Service Bulletin No: 32-029

Modification No: EC-19-0639

**LANDING GEAR - NOSE LANDING GEAR
FORK ASSEMBLY - INSPECTION, REPAIR AND REPLACEMENT****1. Planning Information****A. Effectivity**

Nose Landing Gear Fork Assembly - Inspection
Figure 1

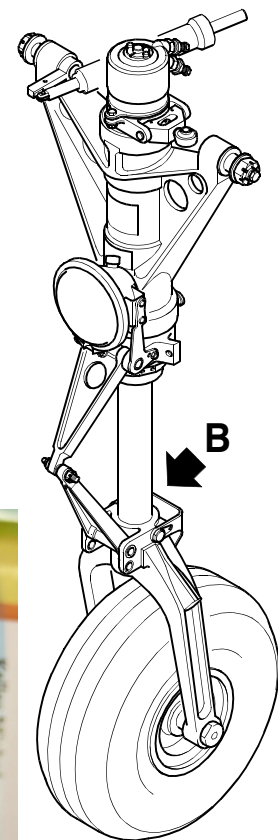
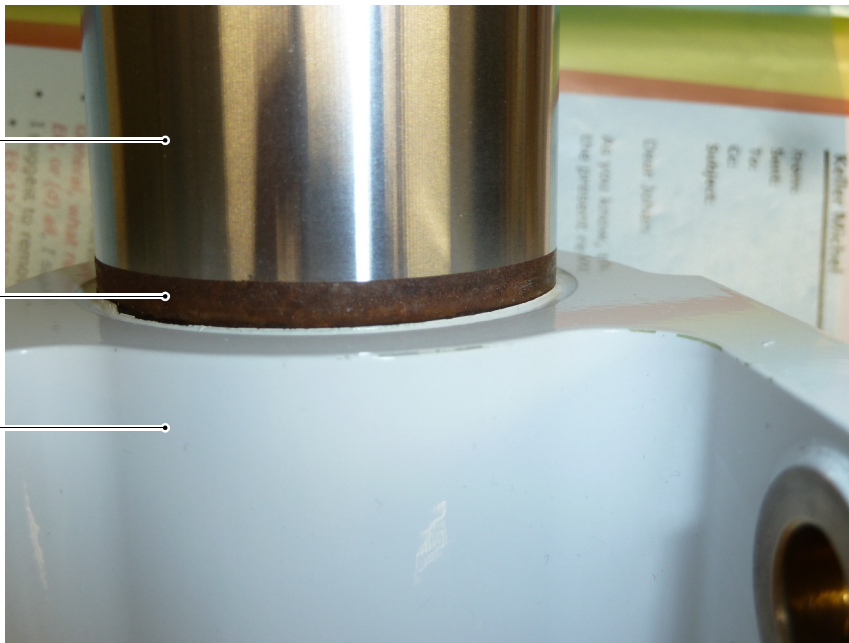
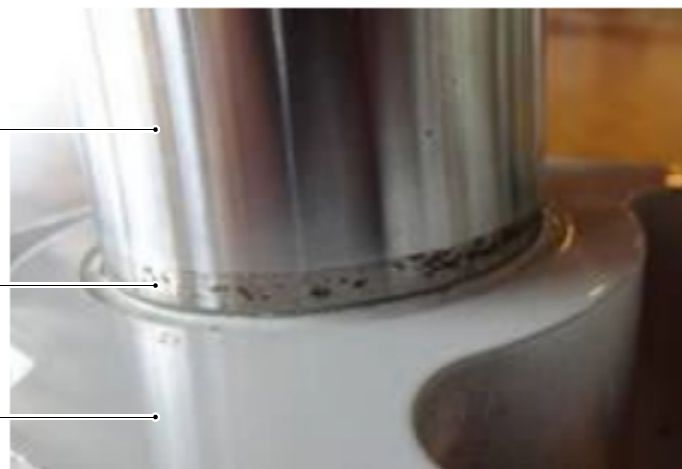
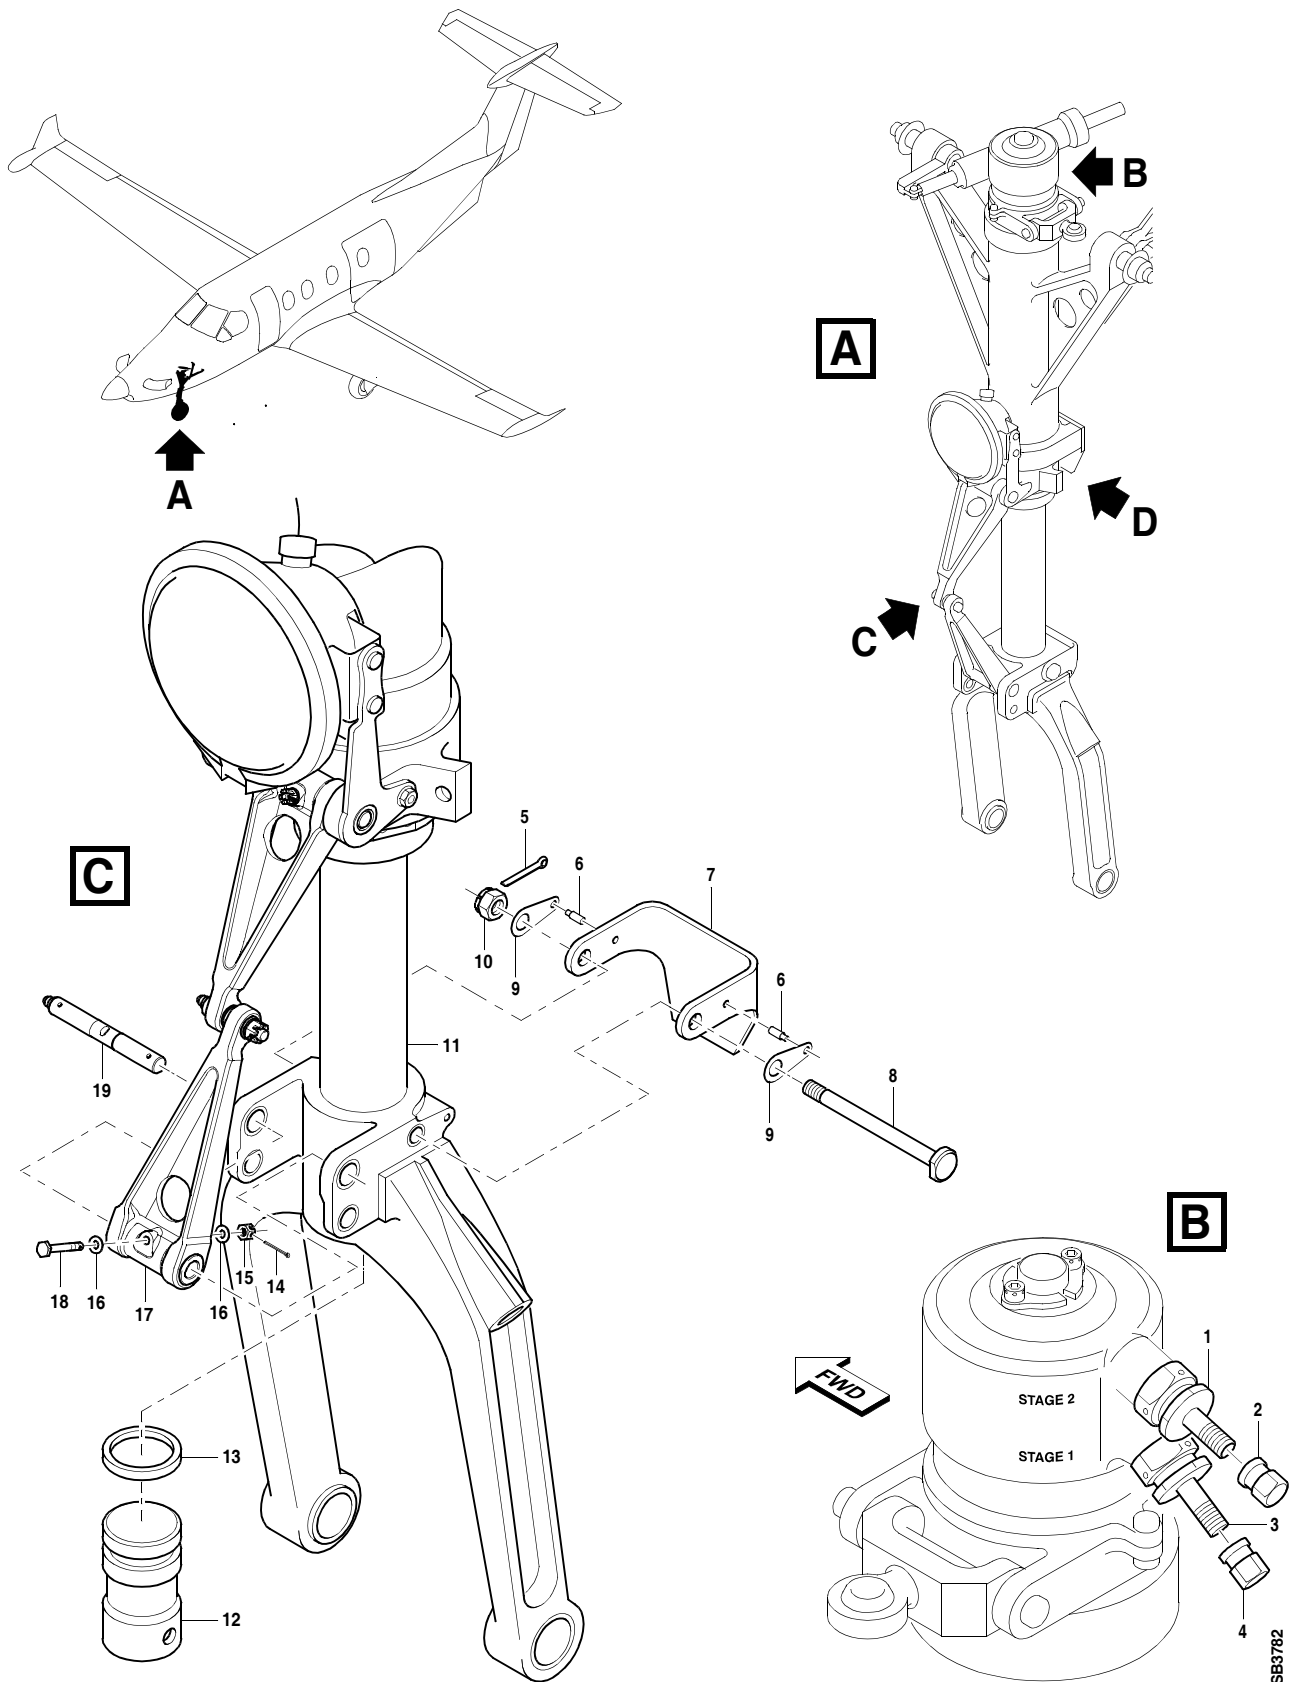
- (1) Make a lint-free cloth (Material No. P02-041) moist with acetone (Material No. P01-016) and clean the cylinder pipe at the nose wheel fork interface in the inspection area.
- (2) Do a visual inspection of the cadmium plating of the cylinder pipe at the nose wheel fork interface. Use a bright light source and magnifying glass if necessary:
 - Cadmium plating is applied to protect the cylinder pipe
 - Corrosion of the cadmium is shown by a white, brown or black color on the surface
 - Corrosion of the cylinder pipe is shown by a red color on the surface.
- (3) Do the instructions for repair of the cylinder pipe in Step 3.C. when you find untreated material (no cadmium plating) with or without corrosion.

- (4) No repair is necessary when sealant or primer and top coat fully covers the cadmium plating between the nose wheel fork interface and the hard chrome plating on the cylinder pipe. Continue with the close up instructions in Step 3.G.
- (5) When you find corrosion of the cadmium plating the cylinder pipe is not affected by this SB:
 - (a) Do the check/inspection procedures, refer to AMM 32-20-01-02A-313A-A.
 - (b) Continue with the close up instructions in Step 3.G.

- (2) Let the acetone dry.
- (3) Do a visual inspection of the cadmium plating of the cylinder pipe at the nose wheel fork interface. Use a bright light source and magnifying glass if necessary:

- Cadmium plating is applied to protect the cylinder pipe
 - Corrosion of the cadmium is shown by a white, brown or black color on the surface
 - Corrosion of the cylinder pipe is shown by a red color on the surface.

- (4) Do the instructions for repair of the cylinder pipe in Step 4.C. when you find untreated material (no cadmium plating) with or without corrosion.

- (5) No repair is necessary when sealant or primer and top coat fully covers the cadmium plating between the nose wheel fork interface and the hard chrome plating on the cylinder pipe. Continue with the close up instructions in Step 4.E.

Nose Landing Gear - Disassembly/Assembly
Figure 2 Sheet 1

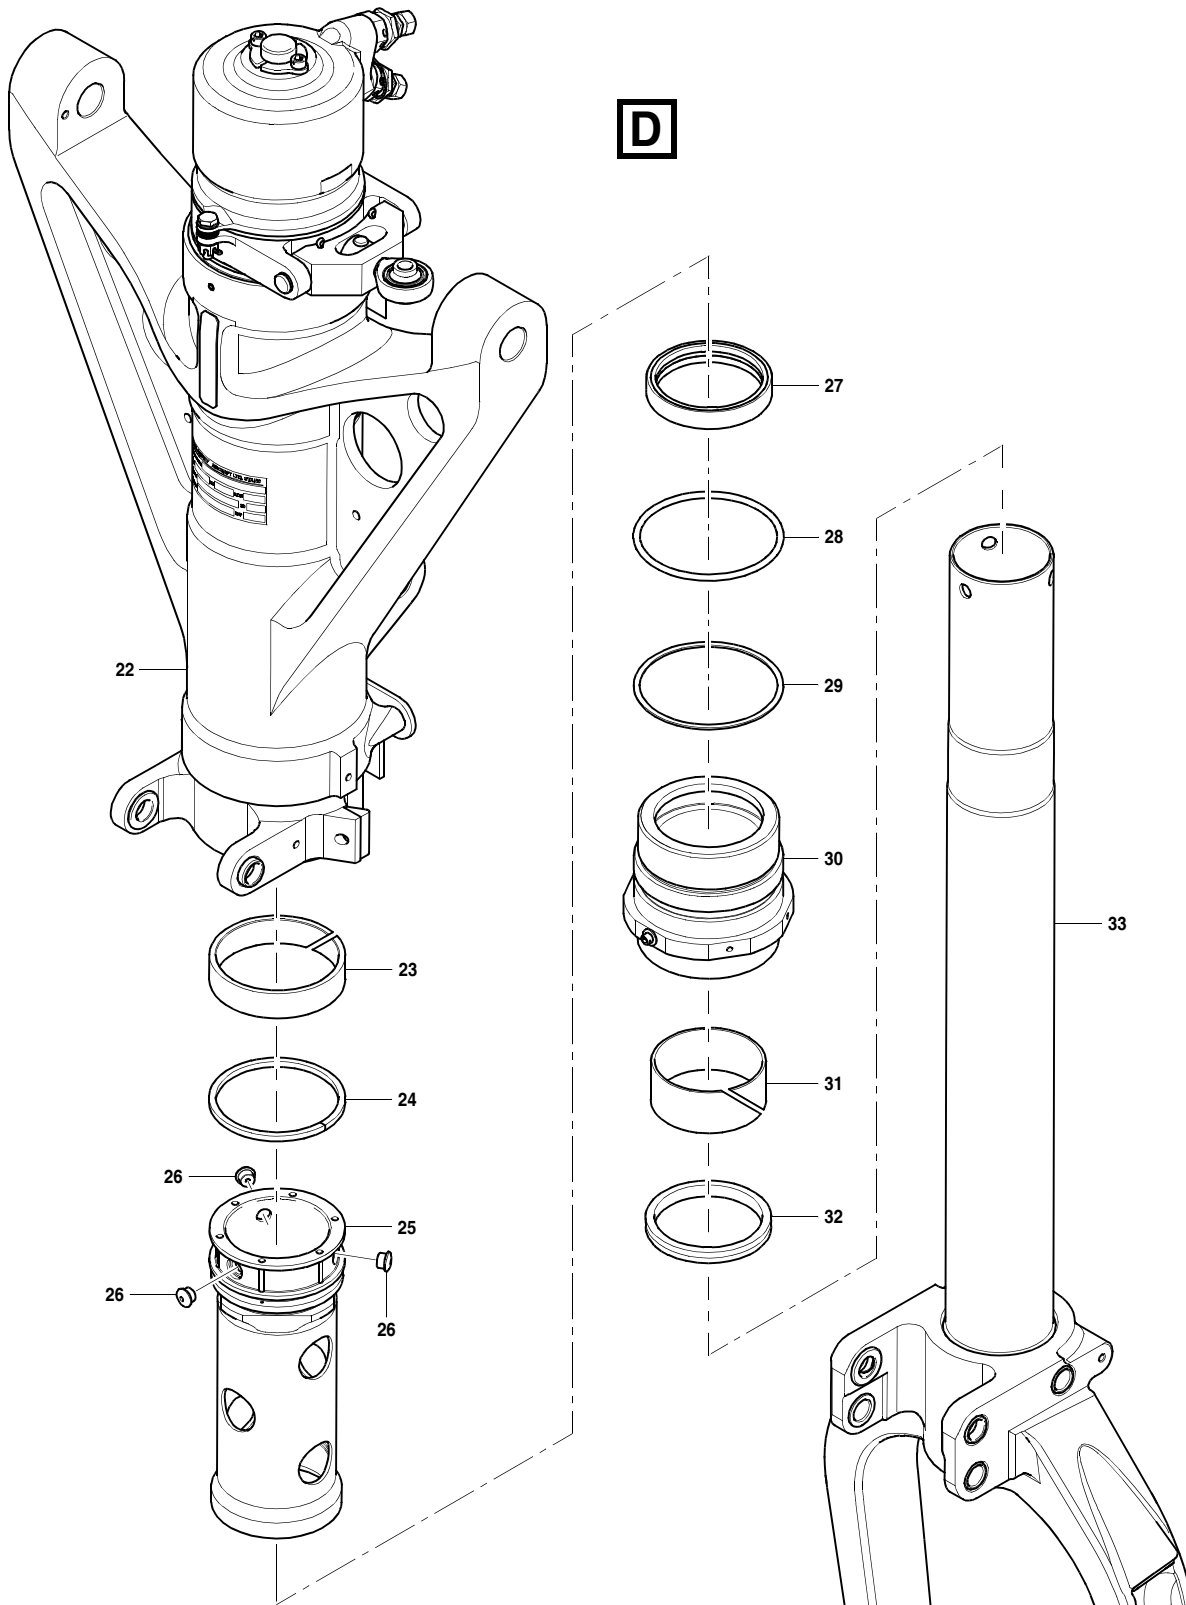
- (1) Disconnect the lower torque link (17) from the nose-wheel fork assembly (11).
 - (a) Remove and discard the cotter pin (14).
 - (b) Remove the nut (15), the washer (16) and the bolt (18).
 - (c) Remove the lubrication pin (19).

- (21) Carefully remove the masking tape and masking paper and allow the sealant to fully cure for 30 hours:
 - After 2 hours at standard conditions (21°C (71°F) with 50% humidity) you can use a hot air blower to reduce the curing time if necessary

- Apply a maximum temperature of 50°C (122°F) in accordance with the manufacturer's instructions.
- (22) Connect the lower torque link (17) to the nose-wheel fork assembly (11):

- (a) Put the lower torque link (17) in position on the nose-wheel fork assembly (11) and install the lubrication pin (19). Make sure that the cut-out in the lubrication pin (19) aligns with the position of the bolt (18).

- (b) Make sure that the lubrication fitting in the lubrication pin (19) is on the right side of the NLG strut assembly.
 - (c) Install the bolt (18), washers (16) and nut (15).

- (d) Safety the nut (15) with a new cotter pin (14) (P/N 940.17.02.502).
 - (e) Apply CPC (Material No. P10-013) around the nut (15) and the bolt (18).

- (1) Make a record of the installed positions of NLG parts during these disassembly procedures to help you when you assemble the NLG parts.
- (2) Make a note of the application of lockwire to parts and fasteners before you remove it. This helps you to safety the parts with lockwire during assembly
- (3) Raise the aircraft on jacks, refer to AMM 07-10-00-00A-901A-A.
- (4) Put spillage containers below the NLG strut assembly.
- (5) Clean the area around the two charging valves (1 and 3) with absorbent paper (Material No. P02-031).
- (6) Remove the caps (2 and 4) from the two charging valves (1 and 3).
- (7) Connect a drain hose and slowly open the STAGE 1 charging valve (3) (to release the nitrogen pressure from the shock absorber). Do not close the STAGE 1 charging valve but remove the drain hose.
- (8) Adjust the STAGE 2 pressure to 4 bar (60 psi).

- (9) Remove the nose wheel, refer to AMM 32-40-02-00A-920A-A.
- (10) Disconnect the lower torque link (17) from the nose-wheel fork assembly (11):
 - (a) Remove and discard the cotter pin (14).

- (b) Remove the nut (15), the washer (16) and the bolt (18).
 - (c) Remove the lubrication pin (19).
- (11) Remove the sleeve (12):
 - (a) Remove and discard the cotter pin (5).

- (b) If necessary, remove the sealant from around the nut (10).
 - (c) Remove the nut (10), the bolt (8), the safety washers (9), the pins (6) and the stop plate (7).

- (d) Use the extracting-tool (P/N 513.32.12.074) and remove the sleeve (12) from the nose-wheel fork assembly (11).
 - (e) Remove and discard the piston seal (13) from the sleeve (12).

- (12) Release the barrel nut (30):
 - (a) Remove and discard the lockwire from the two screws in the barrel nut (30).
 - (b) Loosen the two screws in the barrel nut (30).

- (c) Use the 87 mm spanner (P/N 513.32.12.064) to loosen the barrel nut (30).

- (13) Carefully remove the nose-wheel fork assembly (33) together with the barrel nut (30) and guide pipe (25) attached from the steering tube assembly (22).
- (14) Remove the guide pipe (25):
 - (a) Remove the guide ring (23) from the guide pipe (25).
 - (b) Use the pin extractor (P/N 513.32.12.061) to remove the three driving pins (26).
 - (c) Remove the guide pipe (25) from the nose-wheel fork assembly (33).
- (15) Remove the barrel nut (30) from the nose-wheel fork assembly (33).
- (16) Disassemble the barrel nut (30):
 - (a) Remove and discard the O-ring seal (28) and PTFE seal retainer (29) from the barrel nut (30).
 - (b) Remove and discard the scraper ring (32) from the barrel nut (30).
 - (c) Remove and discard the three parts of the rod seal (27) from the barrel nut (30).

- (1) Lubricate all of the seals, O-ring seals, seal retainers, and other rubber based components with grease (Material No. P04-041 or P04-030).
- (2) Assemble the barrel nut (30):
 - (a) Put the scraper ring (32) in position in the bottom of the barrel nut (30):
 - For scraper ring (32) P/N 946.97.16.342 only, make sure that the O-ring seal installed on the scraper ring (32) faces out
 - For scraper ring (32) P/N 946.97.16.344 only, make sure that the O-ring seal installed on the scraper ring (32) faces in.

- (b) Put the sealing ring (27) in position in the top of the barrel nut (30):
 - The sealing ring (27) is a three part seal
 - Make sure that the rounded edges of the two outer seals mate with the rounded corners of the inner T-seal.

- (c) Install the seal retainer (29) and O-ring seal (28) in position in the external groove of the barrel nut (30).
- (d) Lubricate the inner side of the barrel nut (30) with the hydraulic fluid (Material No. P10-017).

- (e) Obey the manufacturer's instructions and apply a layer of corrosion preventative (Material No. P04-039) on the outer surface of the barrel nut (30) where the O-ring seal (28) is in position.

- (f) Apply a layer of grease (Material No. P04-028) to the threads of the barrel nut (30).
- (g) Put the barrel nut (30) in position on the cylinder pipe of the nose-wheel fork assembly (33). Make sure that it can move freely on the cylinder pipe of the nose-wheel fork assembly (33).

- (a) Put the guide pipe (25) in position on the cylinder pipe of the nose-wheel fork assembly (33). Make sure the holes for the three driving pins (26) are correctly aligned with the holes in the nose-wheel fork assembly (33).

- (b) Use the pin extractor (P/N 513.32.12.061) to install the three driving pins (26) the guide pipe (25) and fork assembly (33). Make sure that the heads of the driving pins (26) are below the adjacent surfaces of the guide pipe (25).

- (a) Install the barrel nut (30) in the steering tube assembly (22) and tighten it with your hand. Be careful you do no damage to the seal retainer (29).

- (c) Use the 87 mm spanner (P/N 513.32.12.064) and torque tighten the barrel nut (30) to between 10,2 and 11,3 Nm (90 and 100 lbf in) plus the run-down torque.

Nose Landing Gear - Cylinder Pipe - Repair
Figure 3

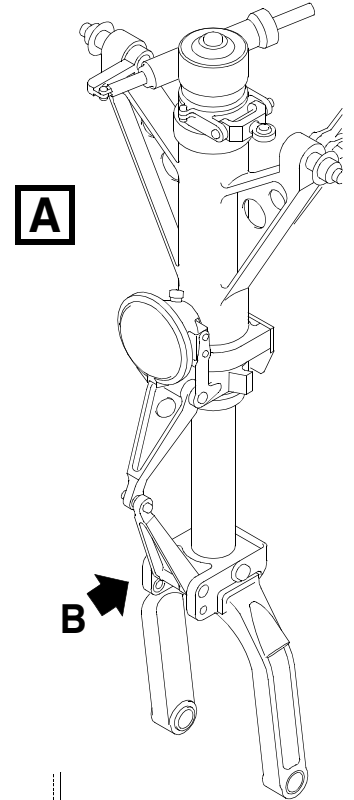
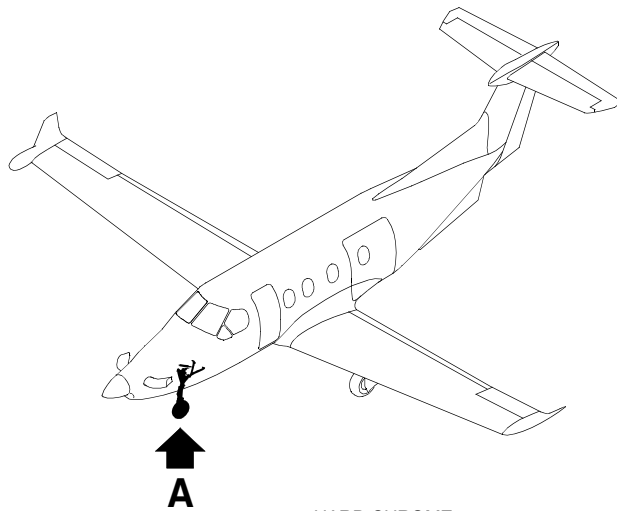
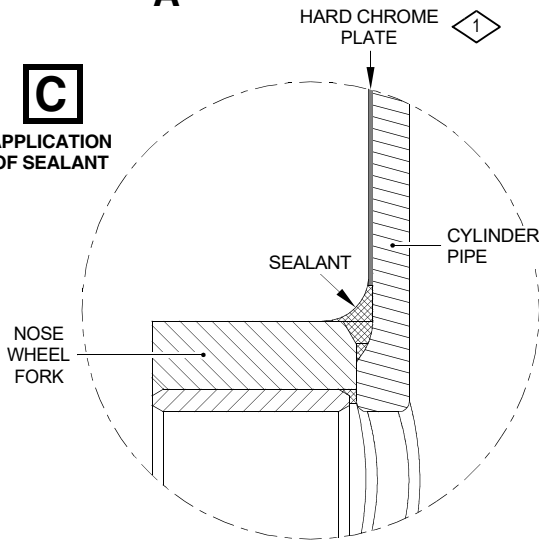
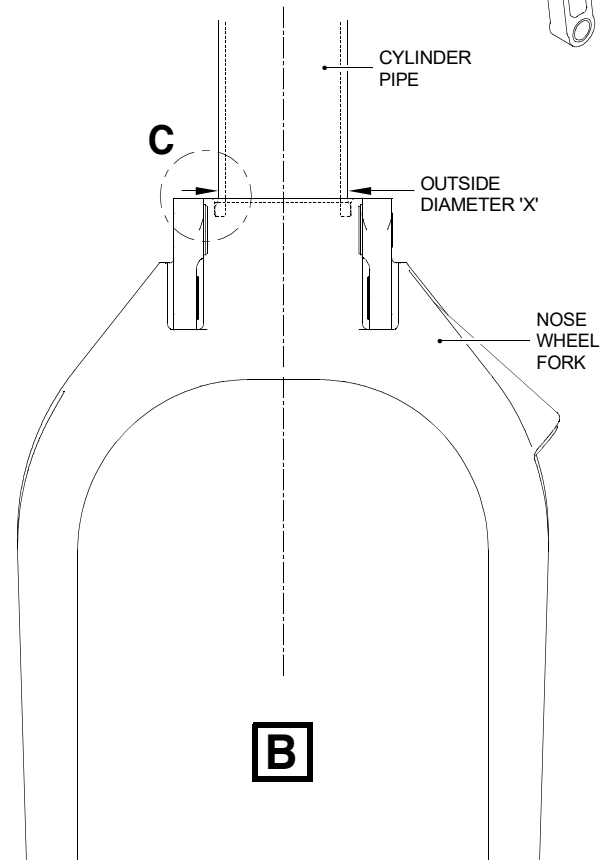
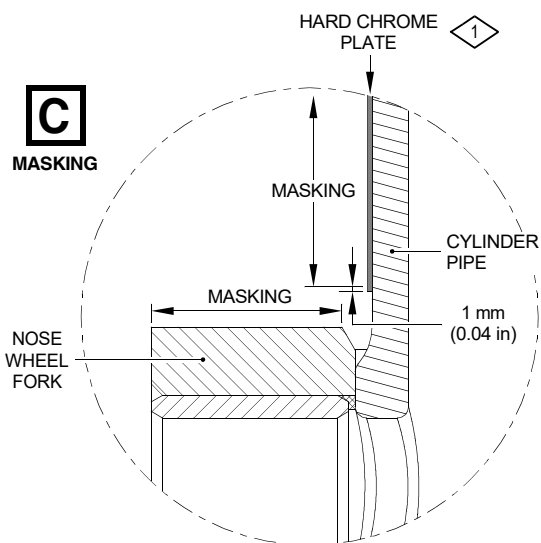
- (2) Apply masking paper (Material No. P09-040) to protect the nose wheel and axle.
- (3) Use non-metallic scrapers to fully remove the sealant between the cylinder pipe and nose wheel fork.

- (4) Make a lint-free cloth (Material No. P02-041) moist with acetone (Material No. P01-016) and clean the interface area between cylinder pipe and nose wheel fork. Let the acetone dry.
- (5) Apply the masking tape and masking paper (Material No. P09-040) to protect the cylinder pipe and nose wheel fork:
 - (a) Apply it to the hard chrome plate on the cylinder pipe approximately 1 mm (0.04 in) from its bottom edge.
 - (b) Apply it around the area of removed sealant on the nose wheel fork.
- (6) Use external callipers to measure and record the cylinder pipe outside diameter 'X' in the untreated material area. Make sure that the outside diameter 'X' is between 56,910 and 57,120 mm (2.240 and 2.249 in).

- (15) Apply the masking tape and masking paper (Material No. P09-040) again to protect the cylinder pipe and nose wheel fork.
- (16) Do a check of the surfaces of the nose wheel fork for bare aluminum.
- (17) Apply a layer of CCC solution (Material No. P07-001) to the bare aluminum of the nose wheel fork if necessary, refer to AMM 20-40-10-00A-901A-A.
- (18) Apply a layer of primer (Material No. P07-007) to all unprotected areas.
- (19) Allow the primer to fully cure for 72 hours:
 - You can use a hot air blower to reduce the curing time
 - Apply a maximum temperature of 50 °C (122 °F) in accordance with the manufacturer's instructions.
- (20) Obey the manufacturer's instructions and apply a fillet of sealant (Material No. P08-018 or P08-071) between the cylinder pipe and nose wheel fork masked area.

Nose Landing Gear - Cylinder Pipe - Repair
Figure 4

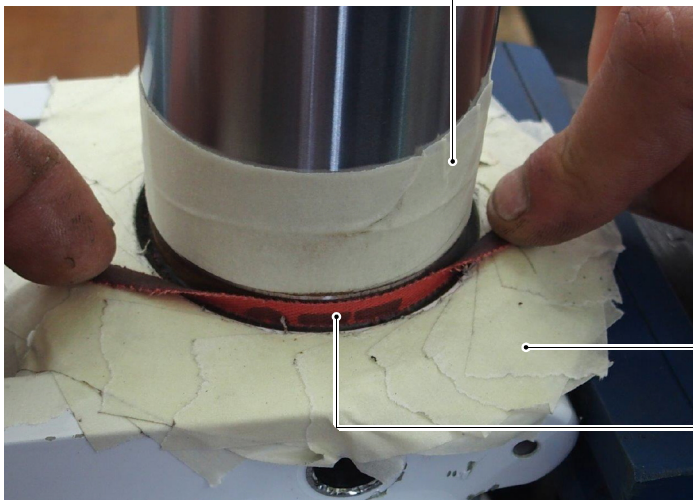
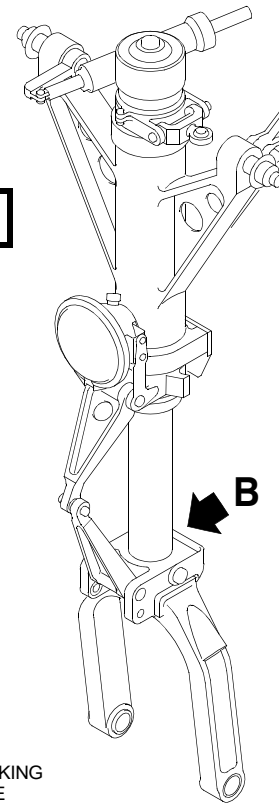
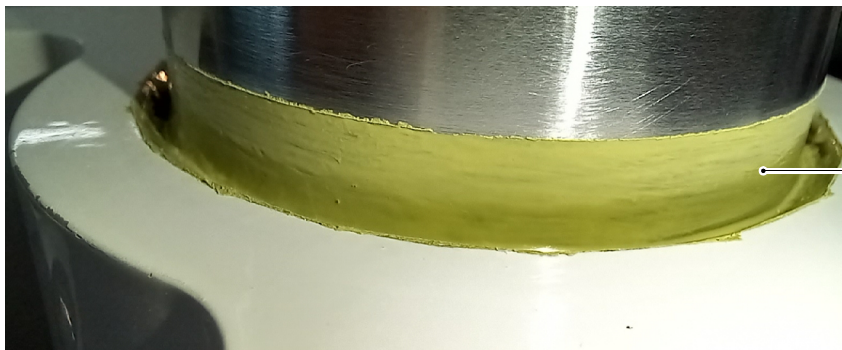
- MAKE SURE THAT YOU DO NOT REMOVE MATERIAL FROM THE NOSE WHEEL FORK.
- (7) Blend out the corrosion as follows:
 - (a) Use abrasive cloth, grade 120 (Material No. P02-009) and abrasive cloth, grade 240 (P02-011) to remove the corrosion from the cylinder pipe in the non-masked area shown in Figure 4:

- 1 Cut the abrasive cloth into thin strips with the same width as the corrosion on the cylinder pipe.
 - 2 Twist the strips of abrasive paper to remove corrosion below the fork level.

- (b) Use diamond riffler files to remove corrosion spots at the hard chrome transition.
 - (8) Use abrasive cloth (Material No. P02-011) to roughen all of the non-masked area.

- (13) Use the external calipers to measure and record the cylinder pipe minimum outside diameter 'X' of the blended area.
 - (14) Do the instructions to replace the cylinder pipe in Steps 3.D., 3.E. and 3.F. when the outside diameter 'X' is less than 55,8 mm (2.197 in).
